TEXAS COMMISSION ON ENVIRONMENTAL QUALITY

Re: Edwards Aquifer, Comal County
NAME OF PROJECT: Kirkwood Manor; Located at the intersection of Loop 337 and Walnut Avenue; New Braunfels, Texas
TYPE OF PLAN: Request for a Modification of an Approved Water Pollution Abatement Plan (WPAP); 30 Texas Administrative Code (TAC) Chapter 213 Edwards Aquifer
Edwards Aquifer Protection Program ID No. 1281.03; Investigation No. 722948; Regulated Entity No. RN102751195

Re: Edwards Aquifer, Comal County
Kirkwood Manor, Modification of Approved WPAP, dated 12/19/2008
Response to first review comments dated February 17, 2009

CONSTRUCTION OF
CELL TOWER
WITH CONSTRUCTION
OF NEW ADDITON

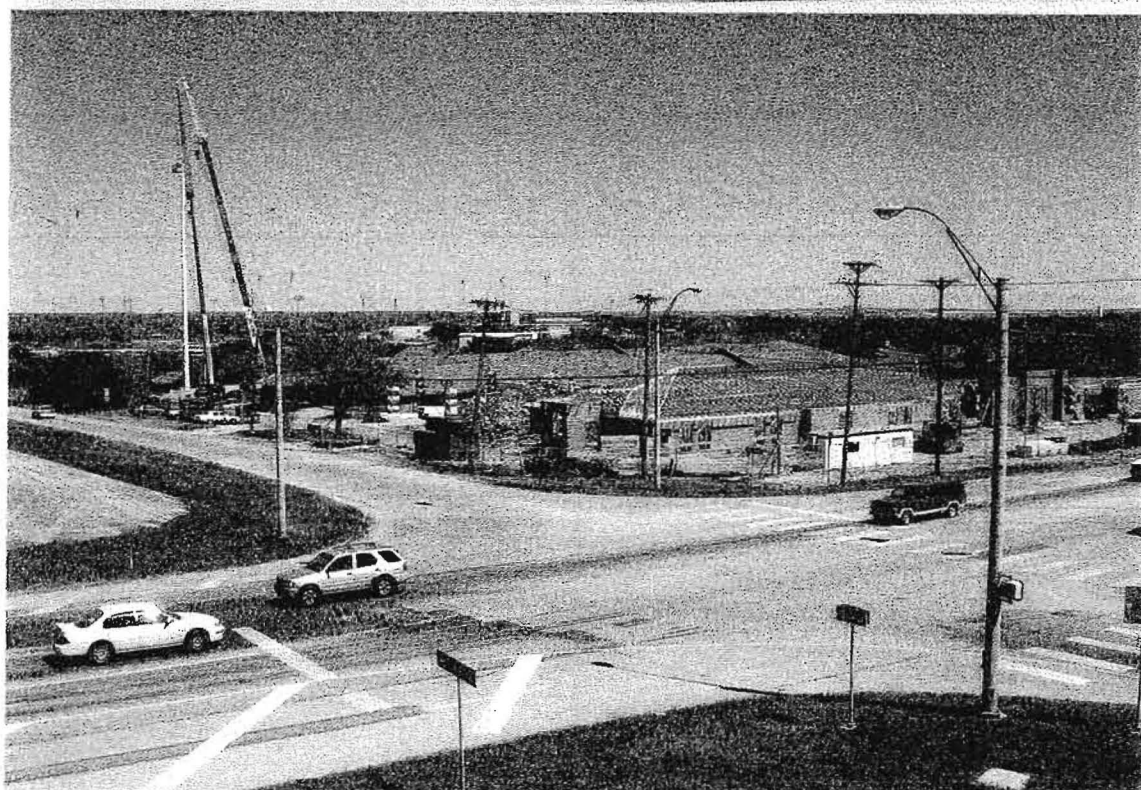
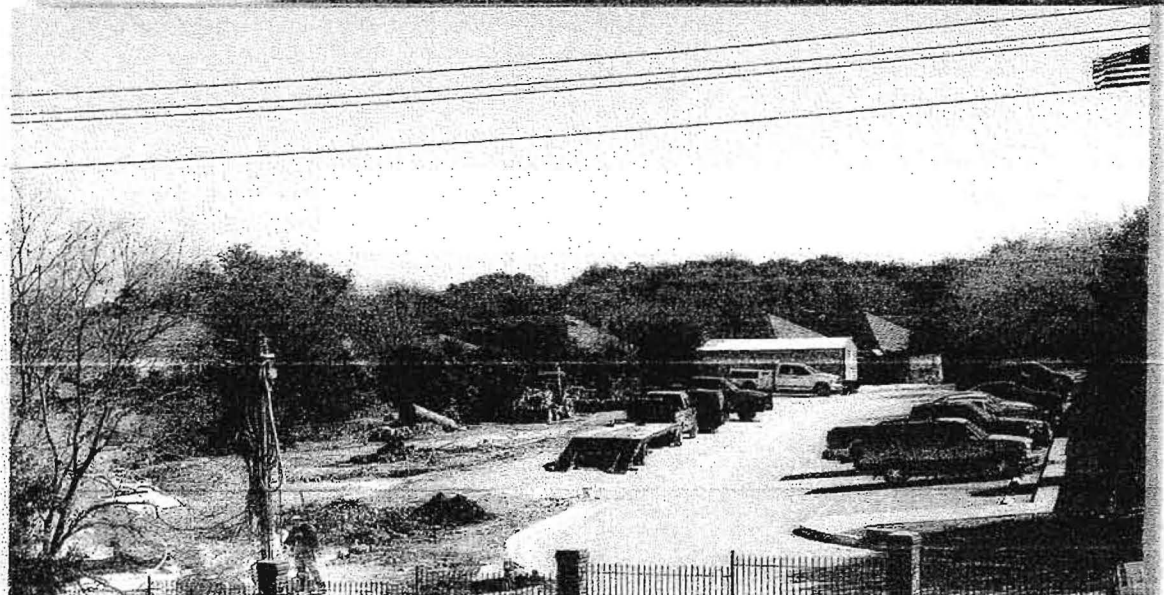
- a. The cell tower and equipment located by BMP do not appear to be a part of any application previously submitted for the site. Please explain and provide any supporting documentation.

The cell tower was not shown on the site plan of the original WPAP, but was constructed at the same time as the nursing facility addition. Attached photos show it under construction at the same time as the nursing facility addition. The area for the cell tower was included in the original WPAP impervious cover of 3.455 under Structure and Rooftop, as shown in TCEQ Form 0584 is 70,567 sf. The main building rooftop is approximately 69,000 square feet as measured from an aerial dated 2008 obtained from Comal GIS at 6-inch resolution (the main building rooftop as measured from the architect CAD file is 67,500), the storage building is approximately 750 sf (from survey), the gazebo is approximately 230 sf (from survey), the cell tower 680 sf (as taken from cell tower plans) for a total of 70,660 sf. The difference, approximately 93 sf or 0.002 acres, is minor and can be attributed to the resolution of the aerial imagery.

BMP1- VALVE

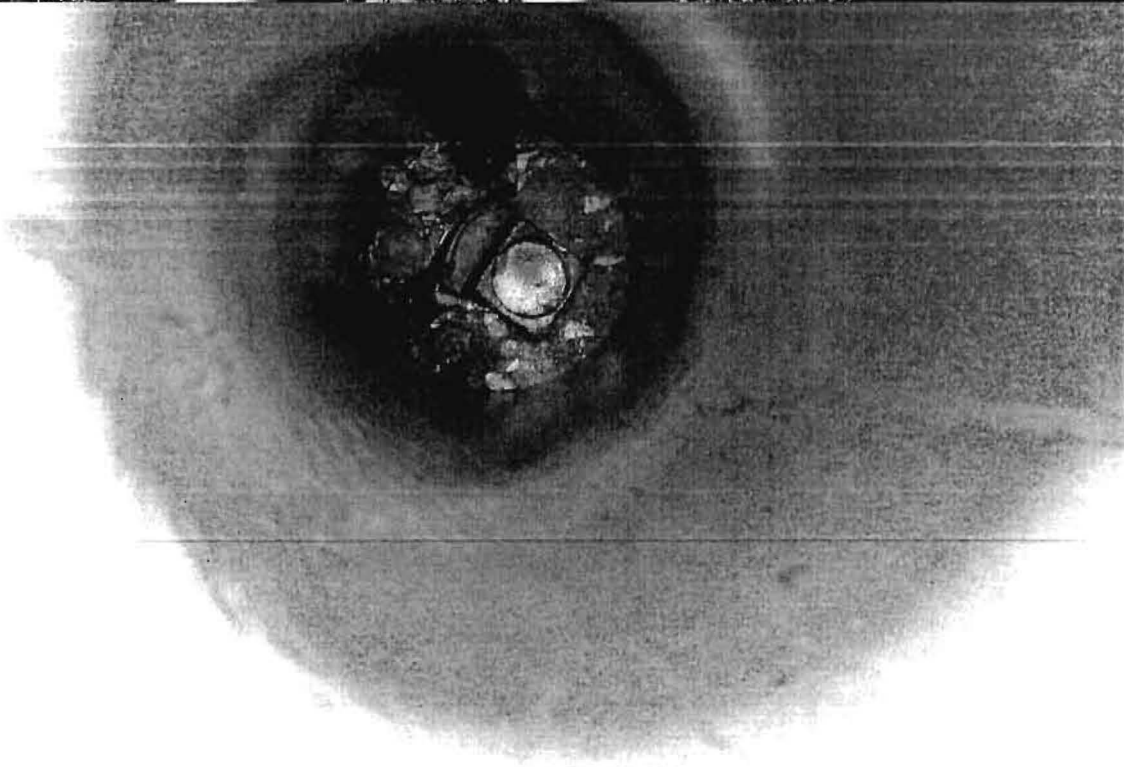
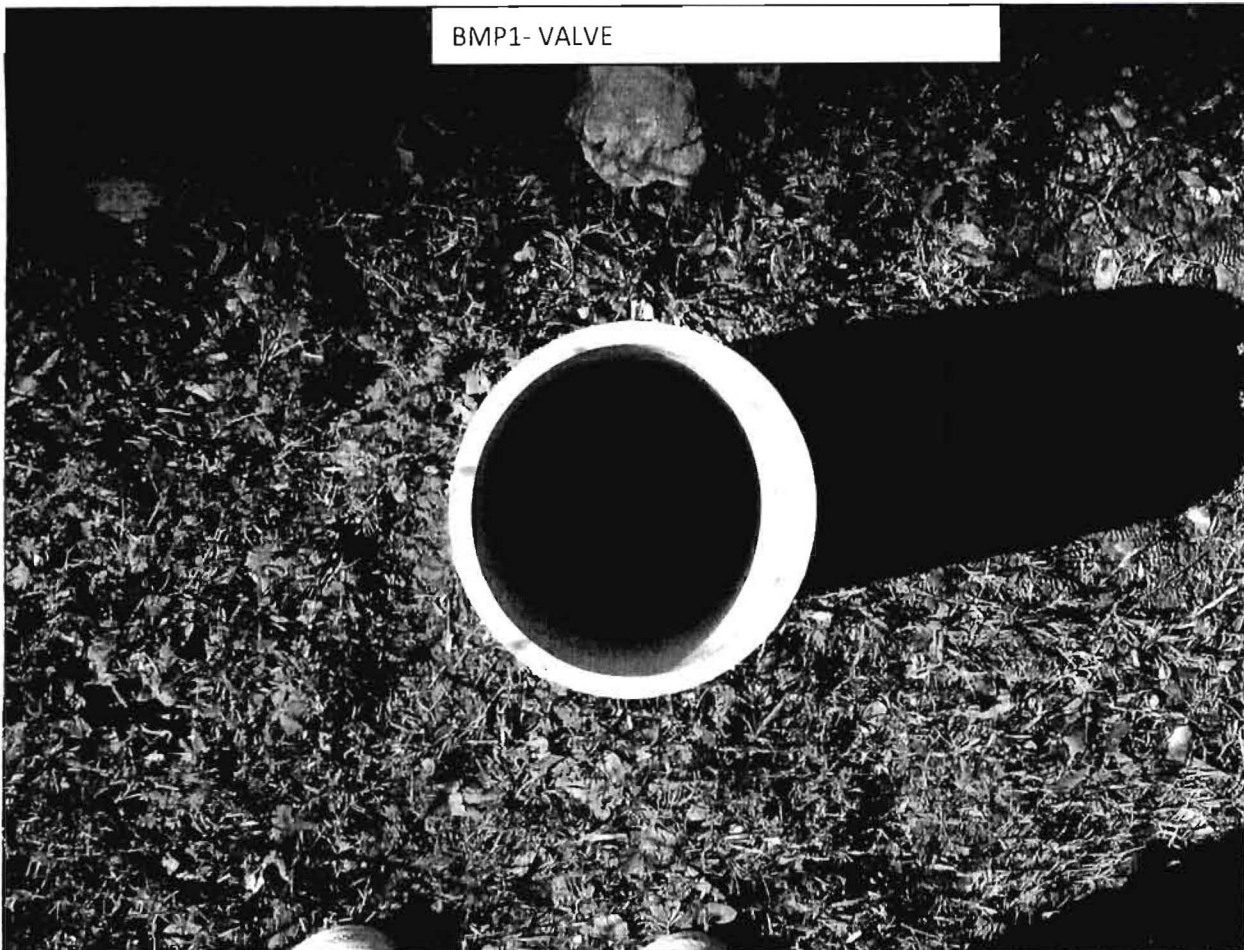
- b. The gate valves for both BMPs appear to be inaccessible due to large amounts of debris on top of the valves. Please maintain the access points so the valves are accessible and provide supporting photographic documentation of the maintenance.

- Pictures of valves of BMP1 and BMP2 free of debris
- Pictures of restored outfall for BMP 2, letter from facility manager attesting to functionality of drain.
